### **HENDERSON COUNTY TECHNICAL REVIEW COMMITTEE**

**SUBJECT:** Revised Master Plan and Development Plan for The Boulders Subdivision (2007-M01) (2017 Revised Master and Development Plan)

## Henderson County Planning Department Staff Report

### Revised Master and Development Plan for the Boulders of Hendersonville (2007-M01)

**Map E: Protected Mountain Ridges Map**

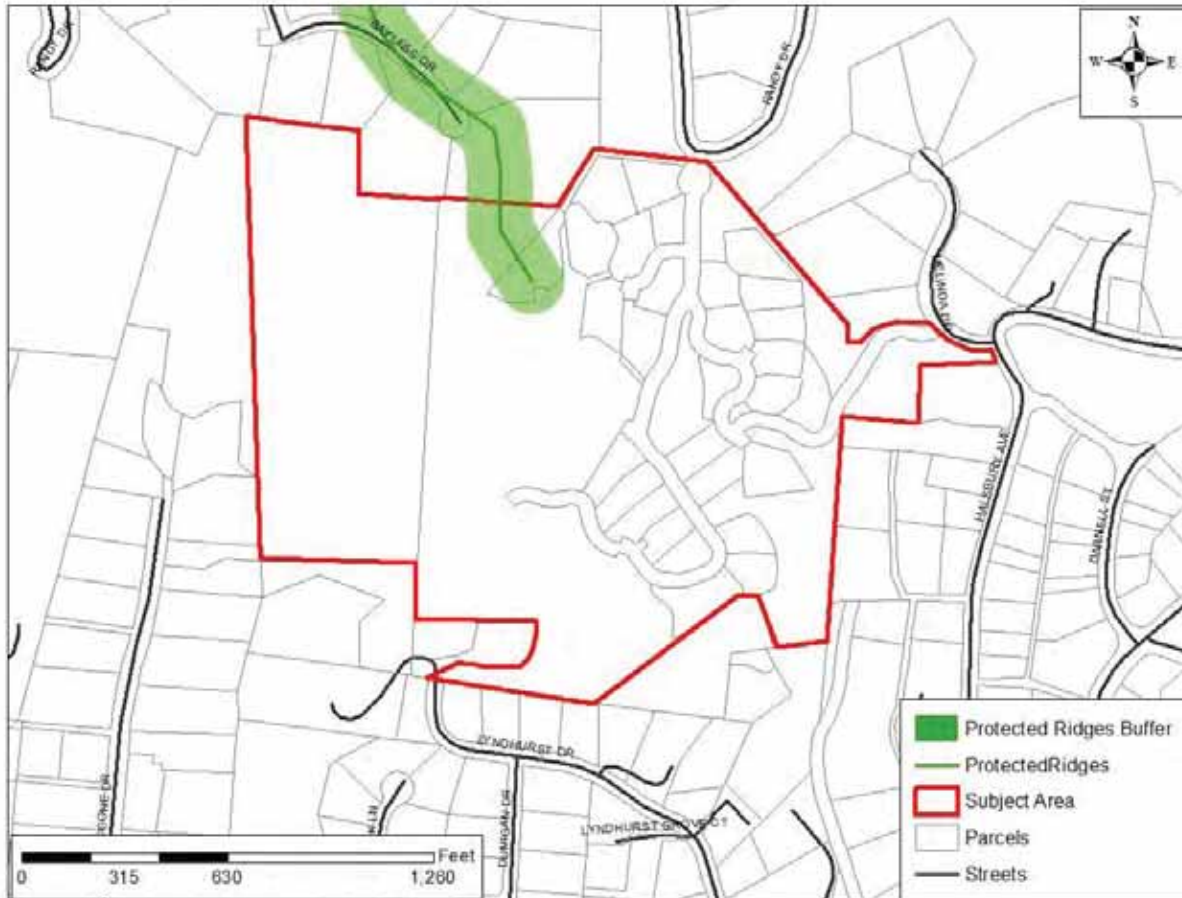
1. **Protected Mountain Ridges.** The project site appears to contain an area effected by the Mountain Ridge Protection Ordinance which states that the provisions of NCGS 113A-209 apply to all mountain ridges in Henderson County whose elevation is 500 feet or more above the adjacent valley floor (Map E: Protected Mountain Ridges). NCGS 113A-209 states that no county may authorize the construction of, and no person may construct, a tall building or structure on any protected mountain ridge. The definition of a tall building found in NCGS 113A-206 is any building with a vertical height of more than 40 feet measured from the top of the foundation and the uppermost point of the building. Additionally, where such foundation measured from the natural finished grade of the crest or the natural finished grade of the high side slope of a ridge exceeds three (3) feet, then such measurement in excess of three (3) feet shall be included in the 40-foot limitation provided that no such building protrudes at its uppermost point above the crest of the ridge by more than 35 feet. The area of ridge under protection is defined as the elongated crest or series of crests at the apex or uppermost point of intersection between two (2) opposite slopes or sides of a mountain, and includes all land 100 feet below the elevation of any portion of such line or surface along the crest. Planning Staff recommends, as a condition of approval, that the Applicant shall adhere to the Mountain Ridge Protection regulations of the County which state that the provisions of NCGS 113A-209 apply to all mountain ridges whose elevation is 500 feet or more above the

adjacent valley floor. Planning staff also recommends that the applicant be required to delineate the protected ridge area on the development plan(s) showing the area within 100 feet below the crest(s).

**Map F: Official Zoning Map**

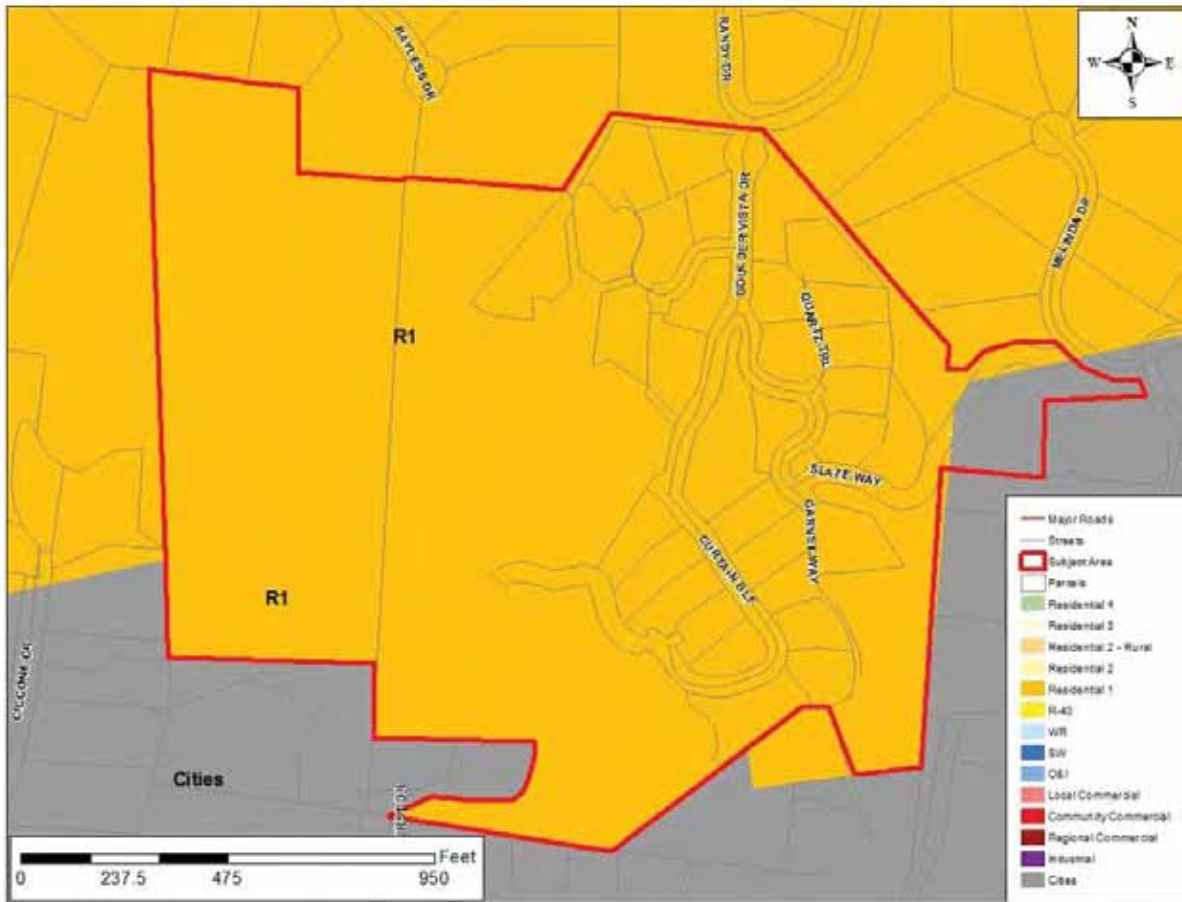
2. **Chapter 200A, Henderson County Land Development Code (LDC).** According to Chapter 200A, Henderson County Land Development Code (LDC) and its Official Zoning Map adopted September 19, 2007 (as amended), the proposed project site is located within the Residential One (R1) (See Map F: Official Zoning Map). The R1 district allows for single-family residential development.

R1 allows for a standard residential density of 4 units per acre where the slope is less than 60 percent. At total of 34.9 acres are in this category, meaning 139 units would be permitted within this acreage. Where slopes are 60 percent or greater, the density shall be one-half ( $\frac{1}{2}$ ) of the eligible density (2 units per acre). A total of 6.8 acres of the project site are in this category, meaning a total of 13 units would be permitted. Therefore, the LDC allows for a maximum of 153 units on the project site. The Master Plan proposal of 58 units would fall within the density permitted by the LDC.

**Map G: Public Water and Sewer Map**

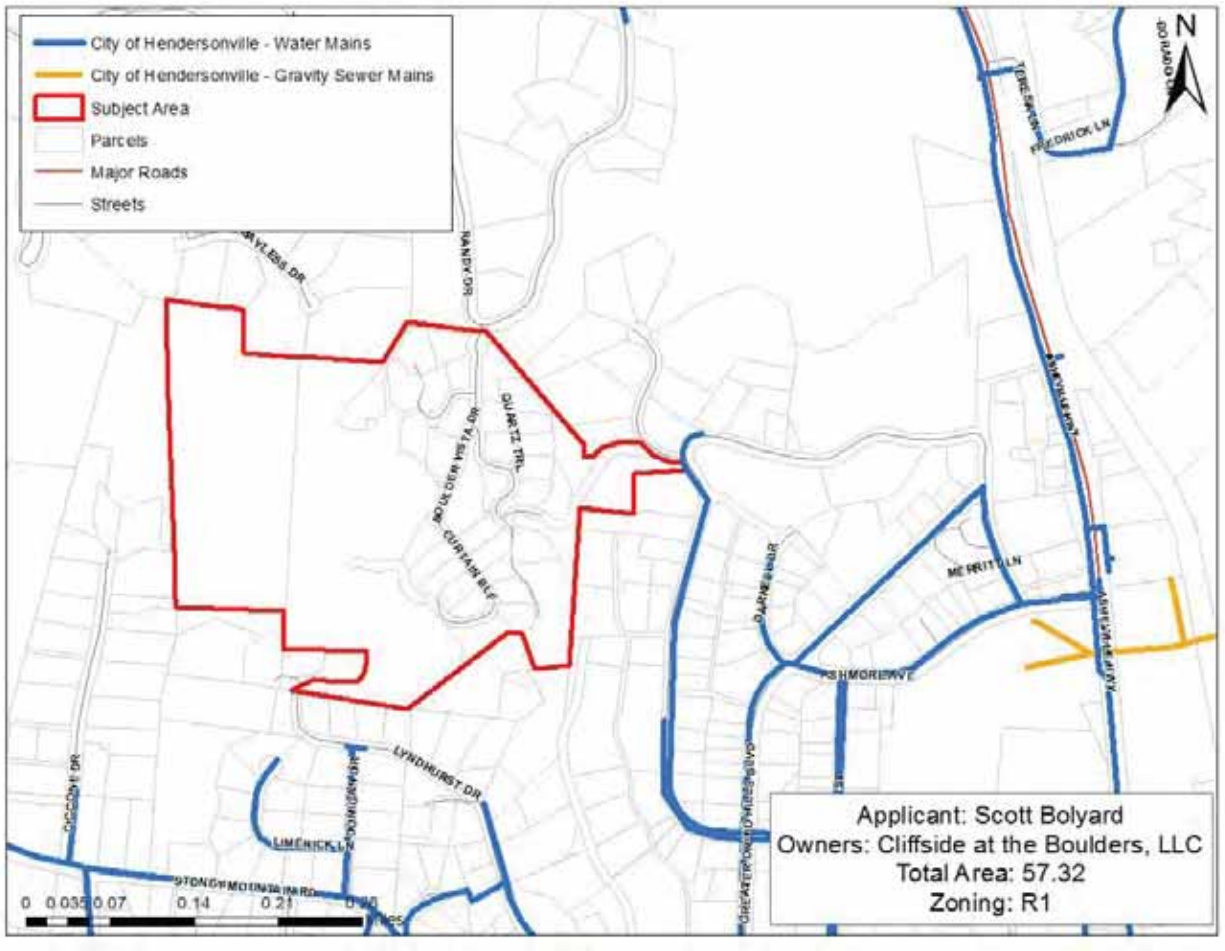
3. **Water and Sewer Availability.** Applicant proposes a public connection to the City of Hendersonville water system on Melinda Drive. The water system within the project site is proposed to be private. The distance to public water from the project site on Melinda drive is 100 feet. The distance to public water from the project site on Lyndhurst Drive is 400 feet.

Applicant proposes private septic systems. Master plan provides a distance to public sewer (from Randy Drive to US 25 N) of 3,500 feet. The site is not close enough to public sewer to require connection (LDC §42-113 C.5).
